September 8, 2020

**RE: Docket Number EERE-2014-BT-STD-0059/RIN 1904-AD97: Notice of Webinar and Availability of Preliminary Technical Support Document for Room Air Conditioners**

**Figure 1. Energy savings of EL 4 relative to EL 3**

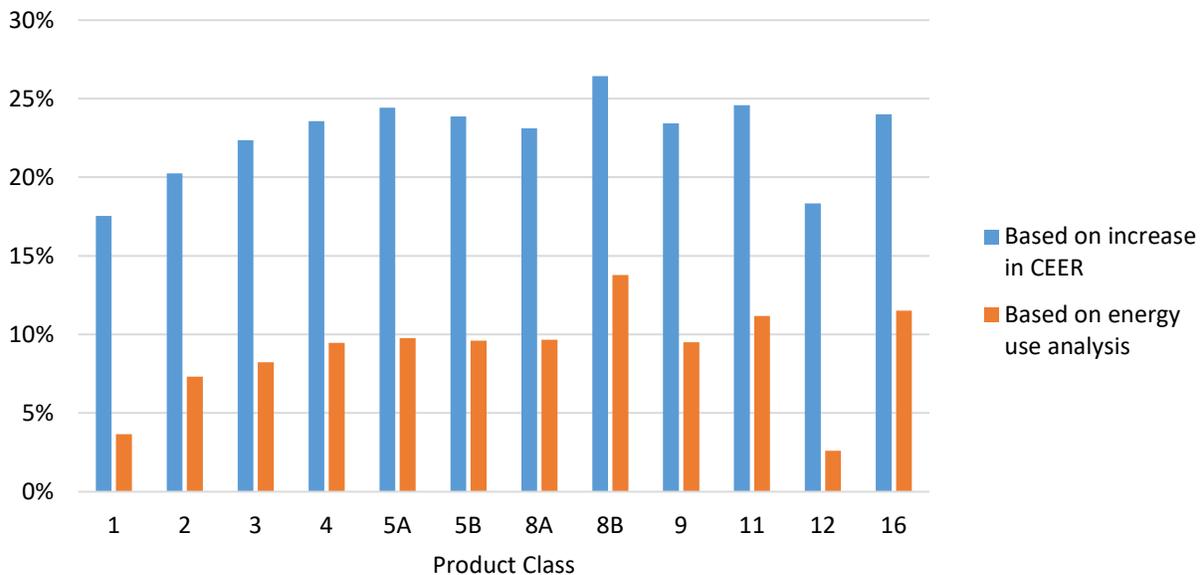
Figure 1 illustrates how DOE’s approach to the energy use analysis for variable-speed room ACs significantly underestimates the savings that variable-speed units can provide. For each of the product classes analyzed in the preliminary TSD, the graph shows the expected energy savings of the max-tech

level (EL 4) relative to EL 3 based on the increase in CEER,<sup>15</sup> and the energy savings at EL 4 relative to EL 3 as shown in DOE’s energy use analysis.<sup>16</sup> While the increase in CEER values would suggest energy savings of 18% to 26%, depending on the product class, the energy use analysis shows savings of just 3% to 14%. For Product Class 1, which DOE estimates represents 31% of all shipments,<sup>17</sup> the energy savings that DOE estimates at EL 4 relative to EL 3 are almost five times smaller than what the increase in CEER (12.7 to 15.4) would suggest.

The preliminary TSD explains that the energy use analysis is intended to “establish a reasonable range of real-world energy consumption.”<sup>18</sup> In the real world, single-speed room ACs will experience significant cycling losses when operating at part-load conditions, as illustrated by DOE’s investigative testing for the test procedures NOPR.<sup>19</sup> In addition to significantly reducing these cycling losses, variable-speed operation improves heat exchanger effectiveness at reduced cooling loads, resulting in additional energy savings that are also illustrated by DOE’s investigative testing. Yet DOE has not captured the large part-load efficiency benefit of variable-speed room ACs in the energy use analysis. We urge DOE to revise the energy use analysis to capture the real-world savings associated with variable-speed compressors.

**Figure 2. Historical market penetration of ENERGY STAR room ACs from 2010-2019**

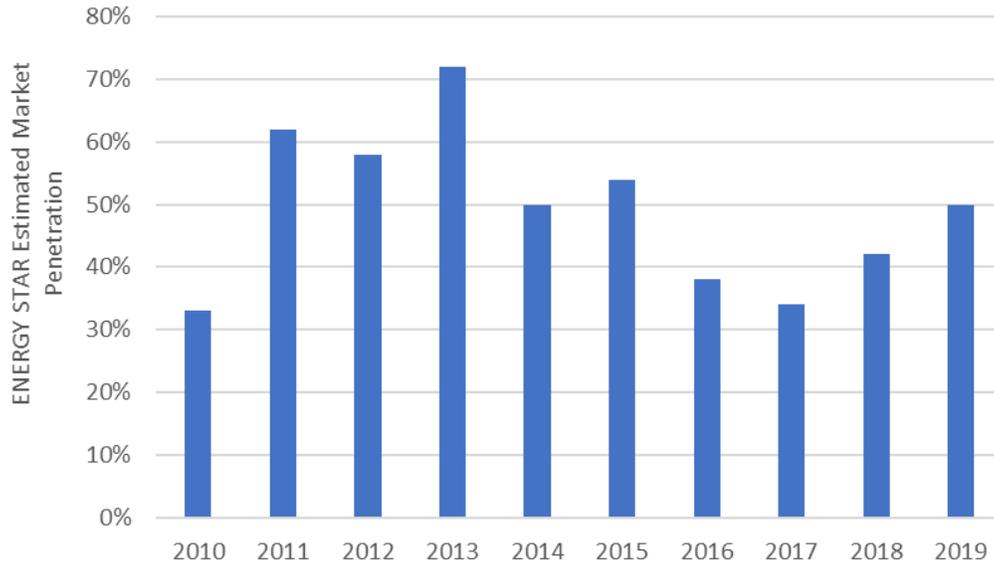
**DOE should consider reevaluating the use of the “roll-up” scenario for estimating the market distribution of each efficiency level following standards adoption.** In the preliminary TSD, DOE modeled a “roll-up” scenario, which assumes that “product efficiencies in the no-new-standards case that do not meet the standard under consideration would ‘roll-up’ to meet the new efficiency level.”<sup>24</sup> However, data on sales over the past decade suggest that a “roll-up” scenario will likely significantly underestimate the savings from amended standards. Figure 2 shows that in each year between 2010 and 2019, the market penetration of ENERGY STAR-qualified room ACs was more than 30%,<sup>25</sup> including in the years following the compliance date of the current DOE standard (2014). Notably, for some product classes, the current ENERGY STAR levels are higher than the max-tech levels from the last DOE final rule.<sup>26,27</sup> For example, for Product Class 1, the max-tech level from the last DOE rulemaking represented a CEER rating of 11.67, while the current ENERGY STAR specification is 12.1.

We would anticipate that the ENERGY STAR levels would be updated in response to amended standards, which would most likely result in an efficiency distribution that includes a significant portion of sales at efficiency levels that exceed the new minimum standard levels. We encourage DOE to consider these real-world market dynamics in order to appropriately account for the energy savings resulting from the adoption of amended standards.
